REQUEST FOR COUNCIL ACTION

Item Description: Request for Approval of a Preliminary Plat at 2201 Acorn Road

REQUEST FOR PLANNING COMMISSION ACTION

Item Description: Request for approval of a preliminary plat at 2201 Acorn Road (PF15-023)

PRELIMINARY PLAT

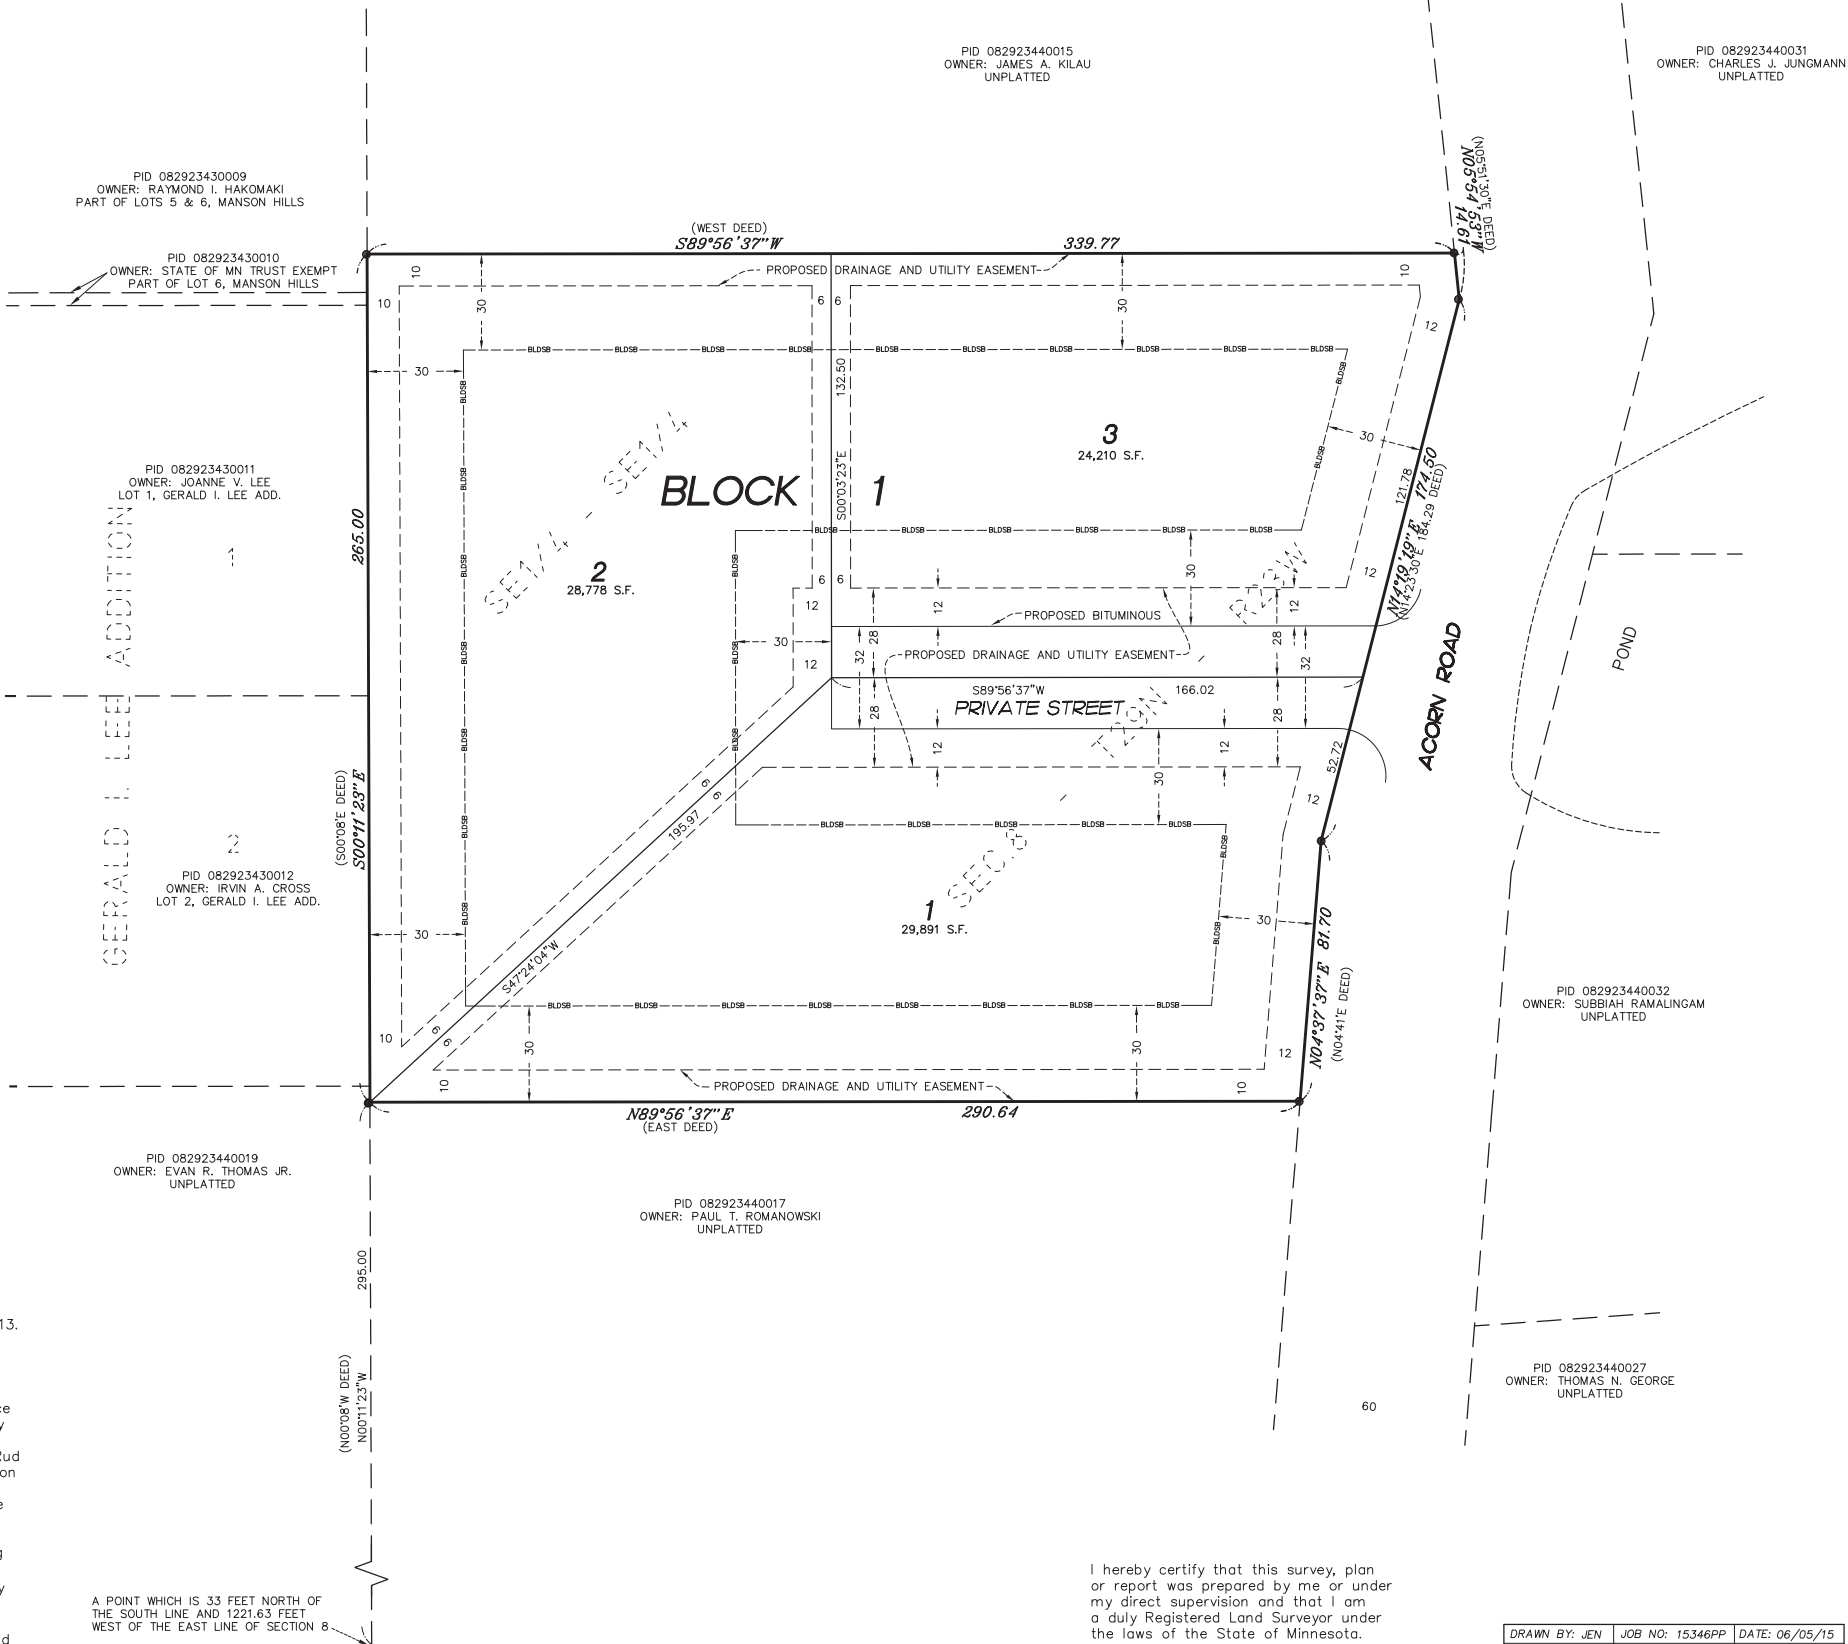
Subd. F of this section specifies that “side lines of lots shall be at right angles or radial to the street line.” Although the western end of the proposed private street is square, Planning Division staff believes that the proposed side boundary common to Lots 1 and 2, extending into the southwestern corner of the existing parcel, meets this requirement because it intersects with the middle of the western end of the proposed street in a radial fashion. If need be, the project engineers have indicated that a semicircle of asphalt can be appended to the western end of the private street so that this side lot line is more obviously radial to the street; it is the opinion of Planning Division staff, however, that adding pavement is unnecessary and would only serve to increase the impervious surface across the development.

Mr. Lloyd provided staff's analysis of this latest Preliminary Plat request from Mr. Mueller as it related to city code. While the subdivision code language provides lots be perpendicular to streets, Mr. Lloyd noted (lines 68 – 76 of the staff report) that the boundary of Lot 1 is perpendicular and even though it could be revised to be radial, staff supported the proposed layout rather than adding additional pavement.

GRADING, DRAINAGE & EROSION CONTROL PLAN
OAK ACRES

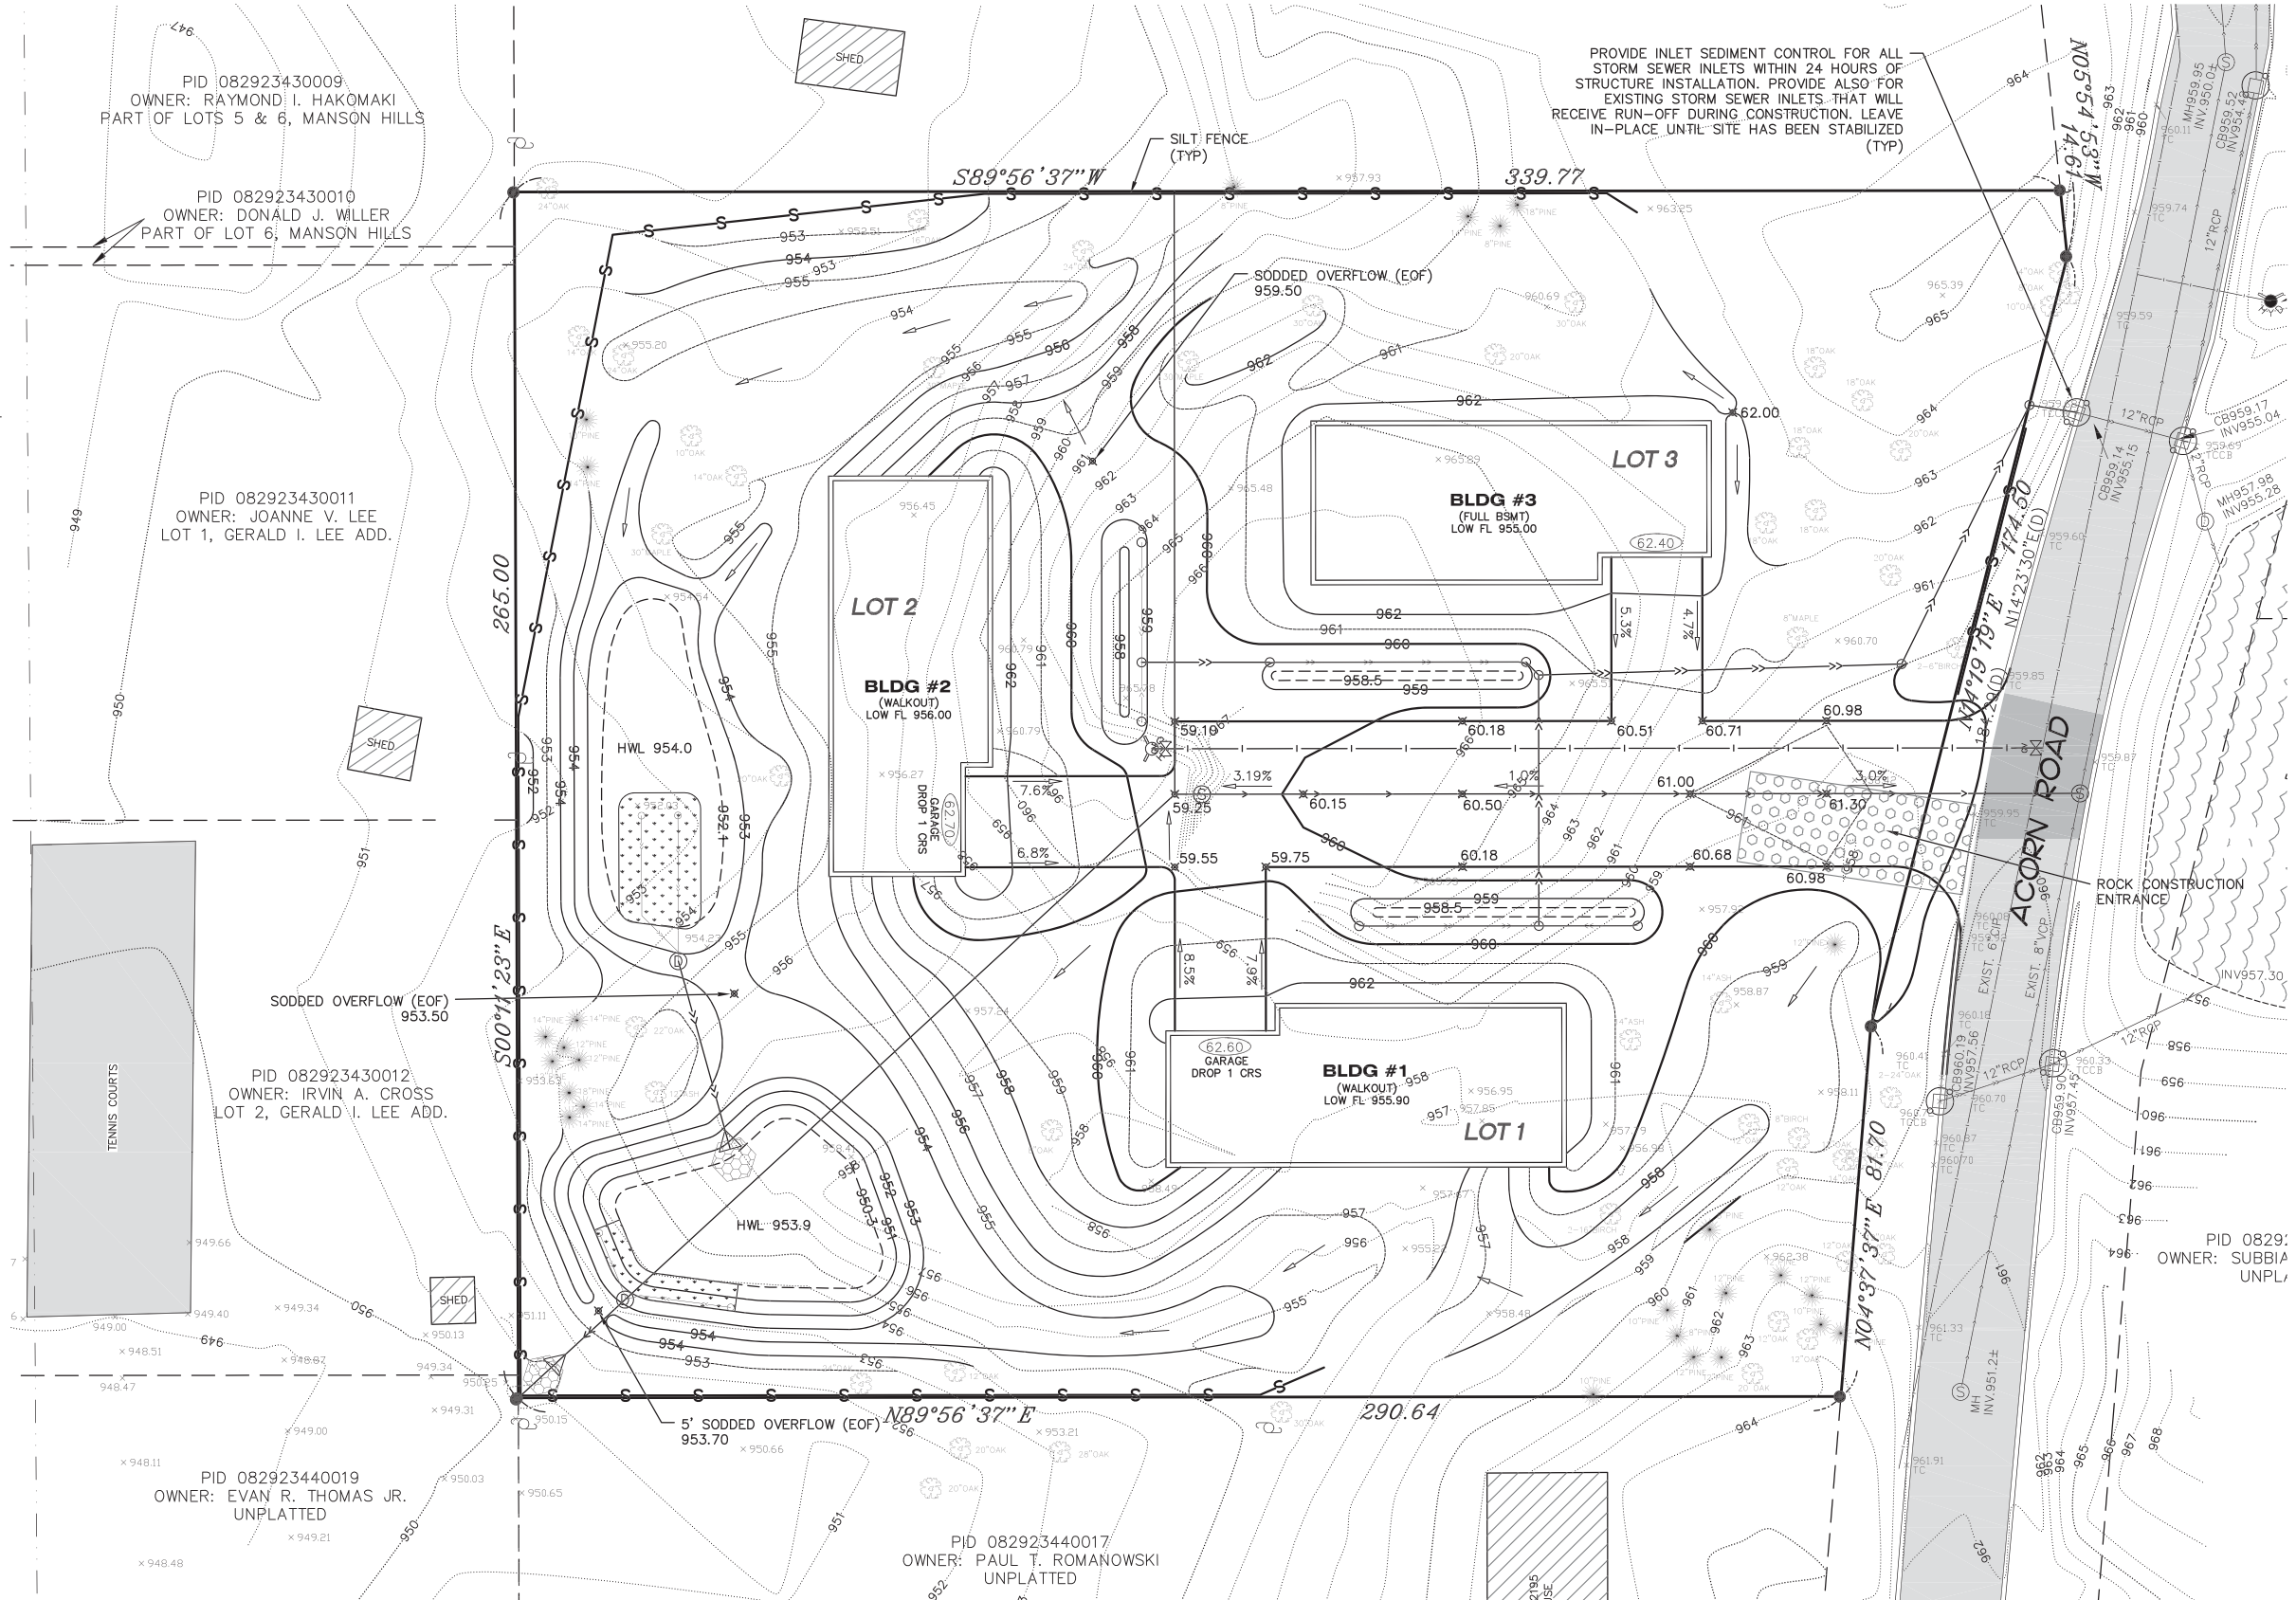
Regarding staff comments and review by the DRC related to stormwater flow toward Acorn Road, Member Bull sought clarification of the actual flow as displayed on the grading plan. Member Bull expressed concern that the proposed infiltration basins may not be empty before the next rain event occurs, causing overland flow issues. Member Bull questioned long-term maintenance of the basins or how the city would address that maintenance.

Mr. Ramalingam reviewed various elevations, gradients, and his calculations with the proposed grading plan and stormwater basins; and potential impacts to Mr. Irv Cross's property on the east side. Mr. Ramalingam further addressed the flow moving from this site to the 8" drain into Acorn Road infrastructure, and questioned if it would be able to accommodate that additional flow, seeking further evaluation by the City Engineer as to how many inches per hour it could accommodate. Mr. Ramalingam asked staff to further evaluate the high water level on the western basin and surrounding area and height differences.

Mr. Ramalingam opined that engineers were addressing low, not high water levels; and groundwater was an unknown in the equation. However, Mr. Ramalingam further opined that the grading plan indicated the basins would be higher than Mr. Cross's property and the water had to go somewhere and based on his calculations, it was currently going to the Cross property.

Mr. Lloyd reviewed the underground connections, overland flow, and reduced flow percentages, noting that not all runoff would be overland, and as modeled, with City Engineers and Mr. Mueller's Engineer still refining the plan, maintenance of the basins would be a requirement of the homeowner's association. However, if the homeowner's association was found at fault in providing that maintenance, the City would step in to address maintenance itself or by hiring a third party to do so, and then assess those property owners accordingly for that cost .

Specific to drainage questions raised tonight by commissioners, Mr. Plowe advised that the rate control would be addressed through catch basins, with the upstream pond built to allow water to drain slowly with minimal if any pooling. Mr. Plowe clarified that this would address the same volume of water flowing into the catch basins as experienced today, but at a slower rate to avoid street flooding.

Regarding concerns raised during public comment about the level of groundwater in basins, Mr. Plowe reported that soil boring information indicated to engineers designing them, that their design should be 3' or more below water basins for infiltration and for the drain tiles to function properly. Mr. Plowe noted that all of these designs would require review and approval by the City Engineer as well as engineers with the Watershed District. Regarding those levels, Mr. Plowe advised that they were typical for down water streams, with water infiltrating and percolating onto adjacent properties with tight soils, thus the reason for drain tiles without the advantage of sandy soils, negating the need for the drain tile system. Mr. Plowe clarified that engineered soil materials would be installed above those drain tiles with the intent to make the water drain down into that system.

In response to Mr. Ramalingam's questions related to the ponds, and whether they would be dry before the next rainfall event begins, Mr. Plowe responded that typically they would be as the soil media and drain tile draws that water level down over a 48-72 hour period; but again noted the City Engineer and Watershed District engineers would also review and ultimately approve the stormwater management plan.
